AMENDMENT OF SOLICITATION/MODIFICATION OF CONTRACT

2. AMENDMENT/MODIFICATION NUMBER 00002
 3. EFFECTIVE DATE 06-05-2018
 4. REQUISITION/PURCHASE REQ. NUMBER 573-18-3-3285-0023
 5. PROJECT NUMBER (if applicable) 573-14-600

Project: Replace Boilers
 Location: Malcom Randall VA Medical Center, Gainesville, FL
 Proposal due date is extended to Wednesday, June 13, 2018, 1:00 PM (Eastern). Per the solicitation, proposals are to be emailed to: William.Clark1@va.gov. Also, per the solicitation, the Bid Bond should both be emailed and mailed.
 Amendment items are attached, and include:
 A. Clause and Provision Changes. B. Revised Price Schedule - Item 2 corrected to indicate DEDUCT and REPLACE.
 C. Geotechnical Report provided. D. All Request for Information (RFI) Responses.
 E. Specification 23 07 11 included (HVAC and Boiler Plant Insulation).
 F. Revised Drawings - Five (5).

Summary of changes in revised sheets dated 5/29/2018:

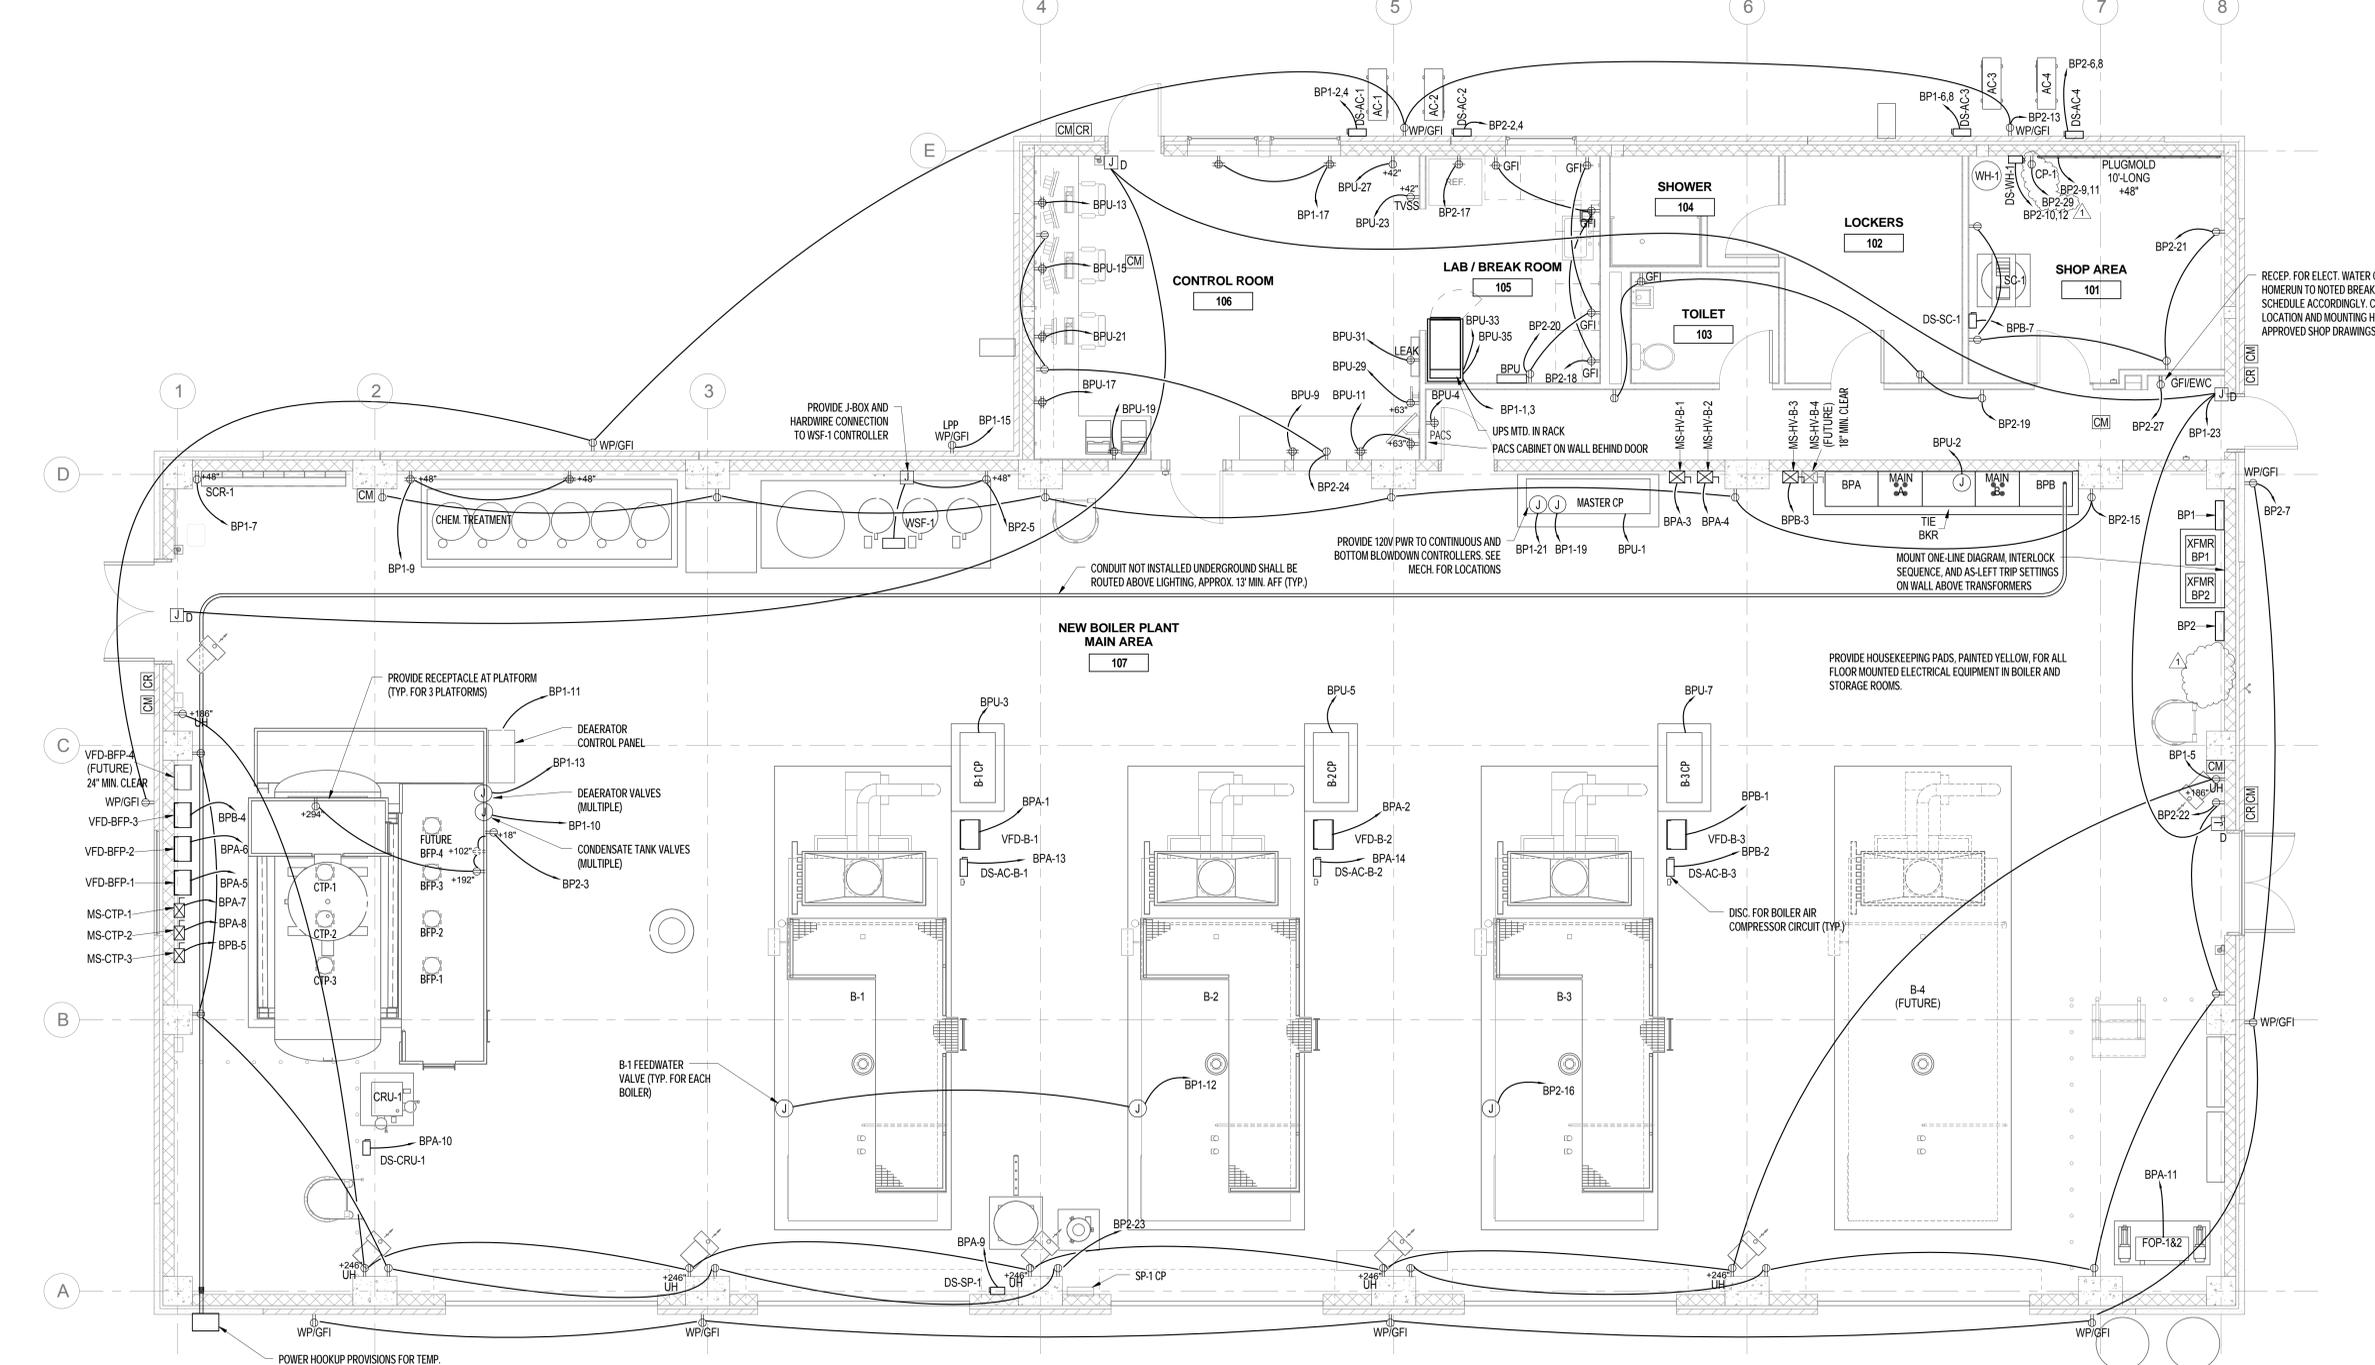
- Receptacle and homerun for CP-1 was added.
- Reference to SFCCP was removed from sheet.

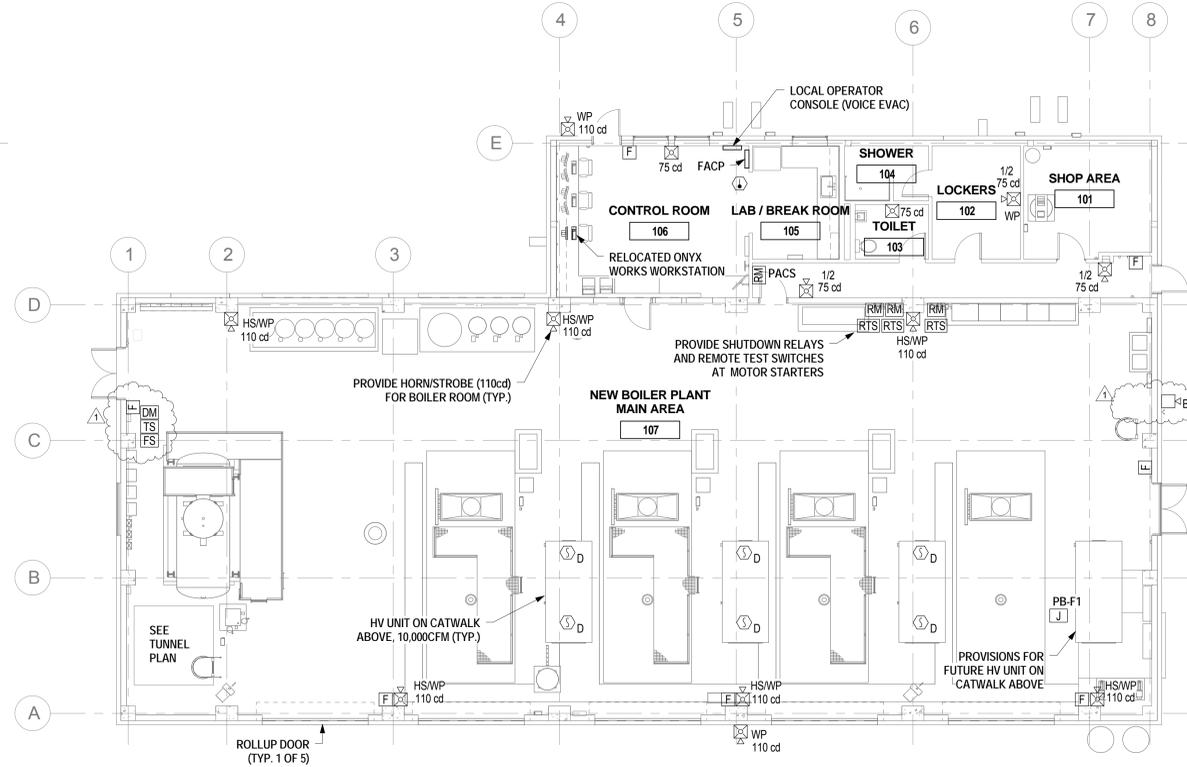
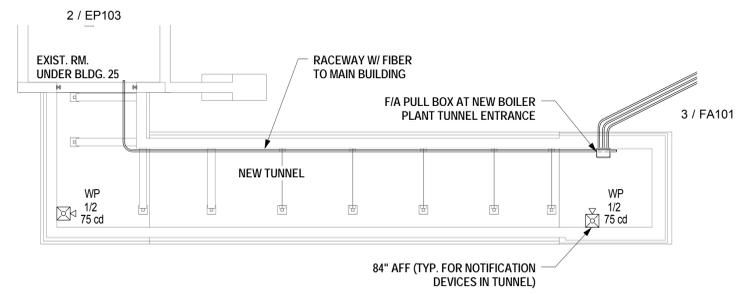
- SFCCP and associated tampers and flows were removed from sheet.
- Tamper, Flow and Dual addressable module were added.
- Exterior bell was added.

MP711

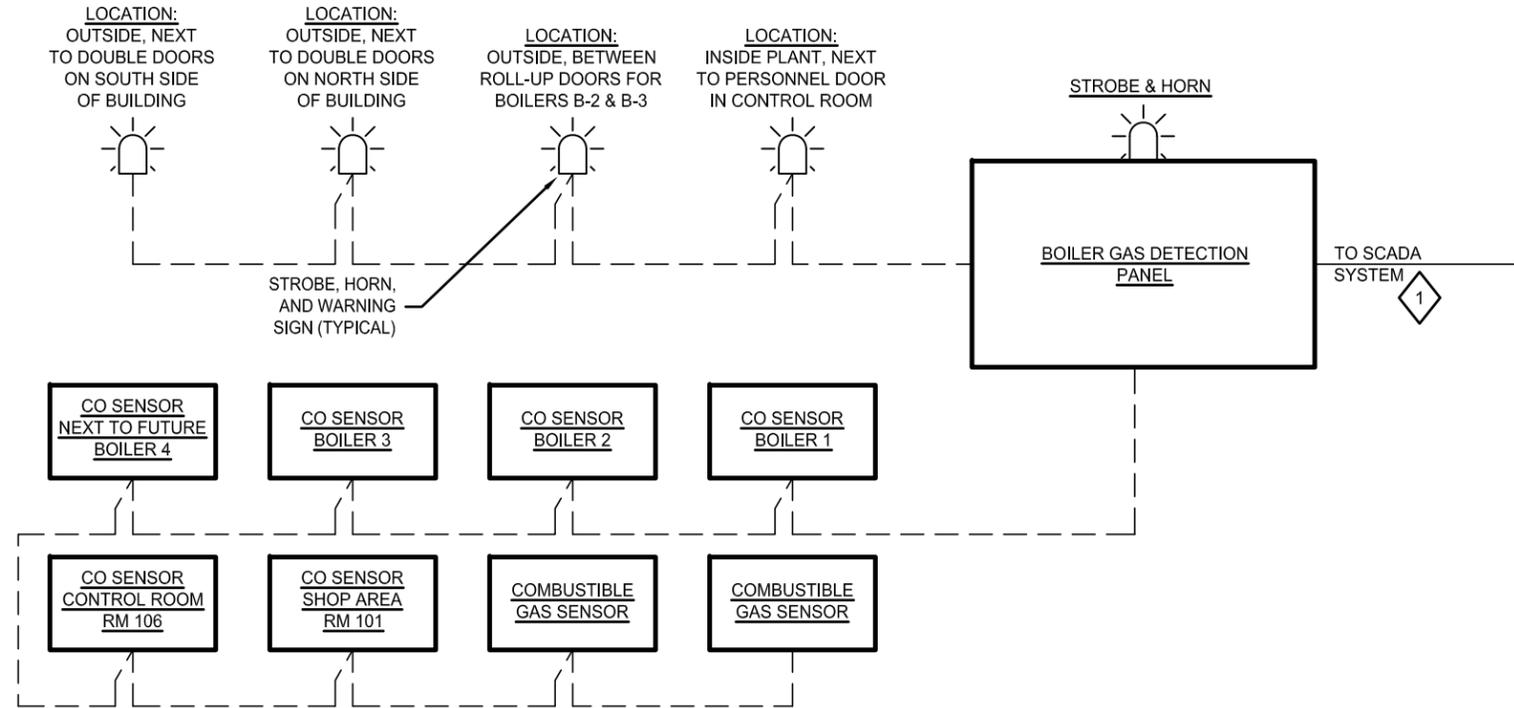
- Boiler Gas Detection System control diagram with audible/visual alarm locations.
